SUBJECT: INSPECTION OF THE FUSELAGE STRUCTURE AT THE AFT BULKHEAD.

AIRCRAFT AFFECTED: BEECHCRAFT Musketeer Model 23 Airplanes, Export and Domestic, that:

REASON FOR CHANGE: To inspect and/or add structural reinforcement to the aft fuselage section and aft bulkhead.

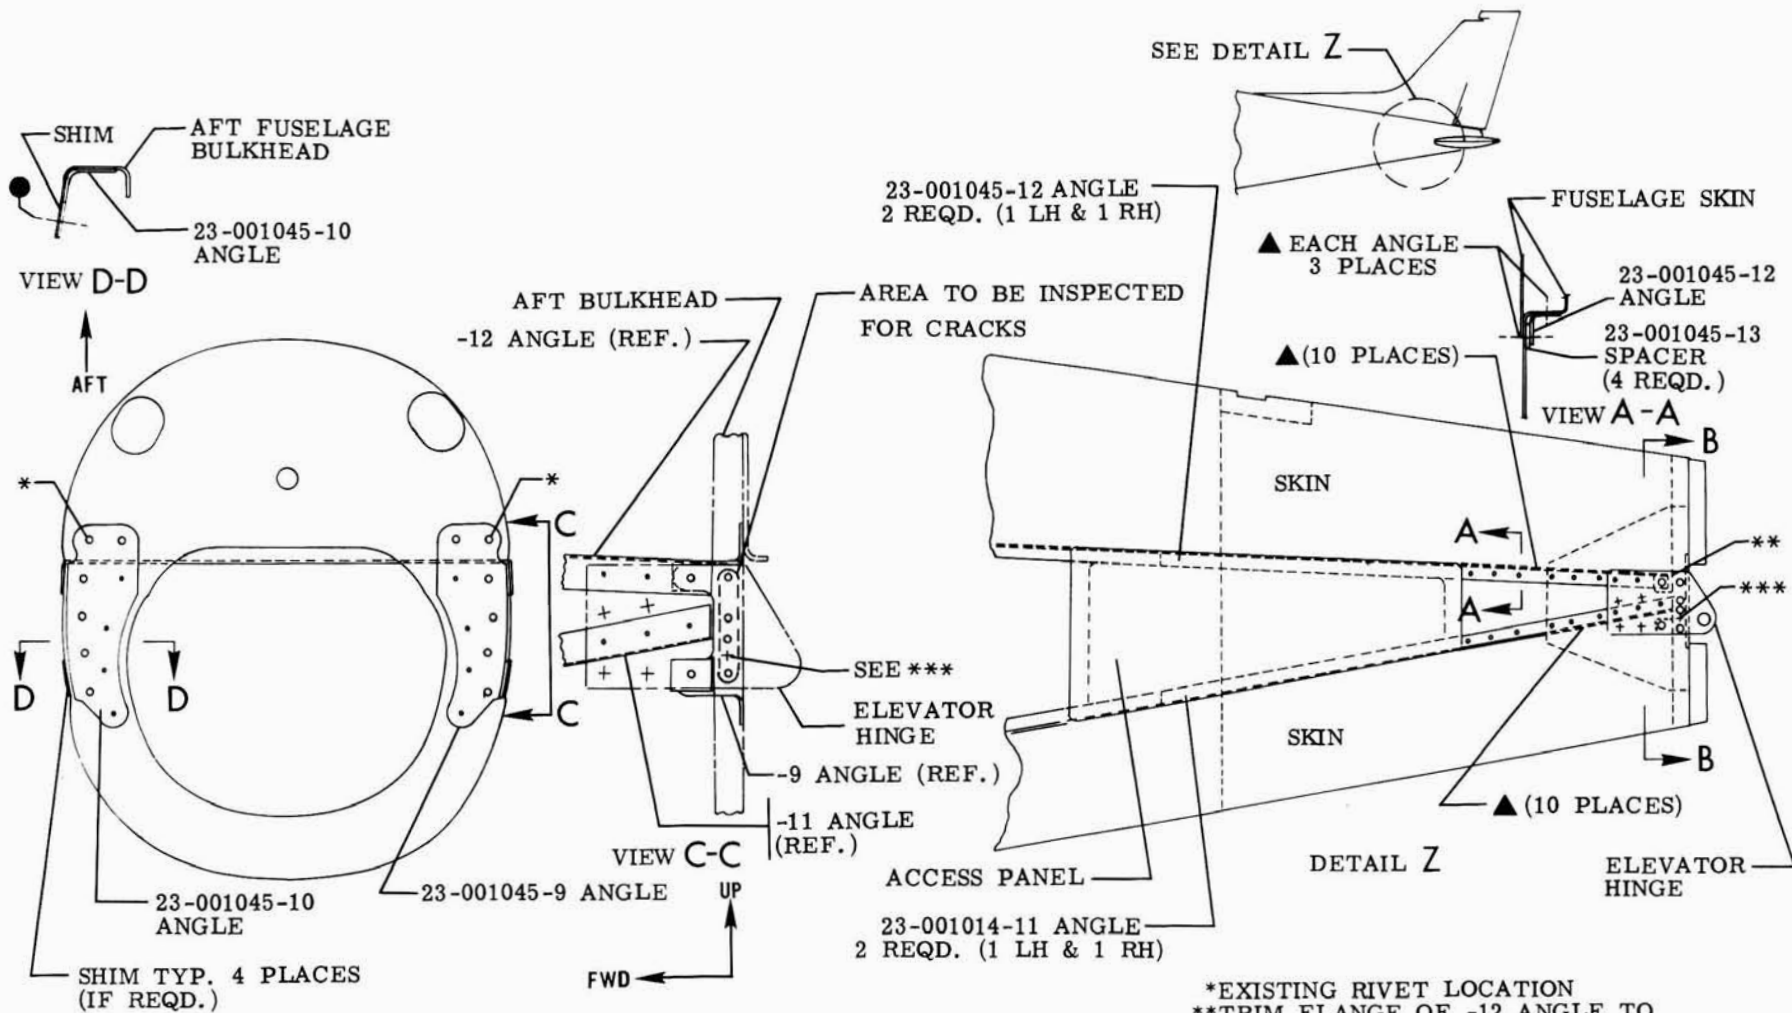
DESCRIPTION: This bulletin is issued to inform owners of BEECHCRAFT Musketeers who were unable to participate in the Musketeer Model 23 factory up-dating and modification program, or who have not installed Kit 23-10SR or Kit 23-11SR, of an inspection and/or modification repair of the aft fuselage structure at the aft bulkhead. This repair is recommended to prevent the possibility of the development of cracks in the aft bulkhead flange, where the five rivets attaching the stabilator hinges are installed (see illustration).

To perform the inspection remove the two access panels, one on each side of the aft fuselage, just forward of the stabilator and check for cracks progressing outward from the five (5) rivet butts in the aft bulkhead flange at the stabilator hinge bracket tie-in. If cracks are found in the bulkhead flange at the rivet butt it is recommended that a repair be made in accordance with Manual CAM 18 for in-field repair.

6. Locate the new angles on the aft bulkhead. Drill the angle to match the two existing rivet locations on the bulkhead. Drill through the bulkhead flange, hinge and fuselage skin five places to match the angle. Drill the remaining locations as required to match the locations in the angle. Drill all holes as required to full size and rivet the angles and spacers with rivets as noted. (Use shims under angle tabs if required.)

● a. Drill #19 (.165 to .174) inch diameter holes for the $5/32$ inch diameter MS20470AD5 rivet. Use rivet length as required (see illustration).

▲ b. Drill #30 (.128 to .137) inch diameter holes for $1/8$ inch diameter MS20470AD4 rivet. Use rivet length as required (see illustration).

*EXISTING RIVET LOCATION
 **TRIM FLANGE OF -12 ANGLE TO CLEAR -9 & -10 ANGLE
 ***REMOVE EXISTING RIVET THIS LOCATION & ADD A FLUSH RIVET THRU HINGE, SKIN & BULKHEAD. THIS RIVET DOES NOT FASTEN THE 23-001045-9 OR 23-001045-10 ANGLE.
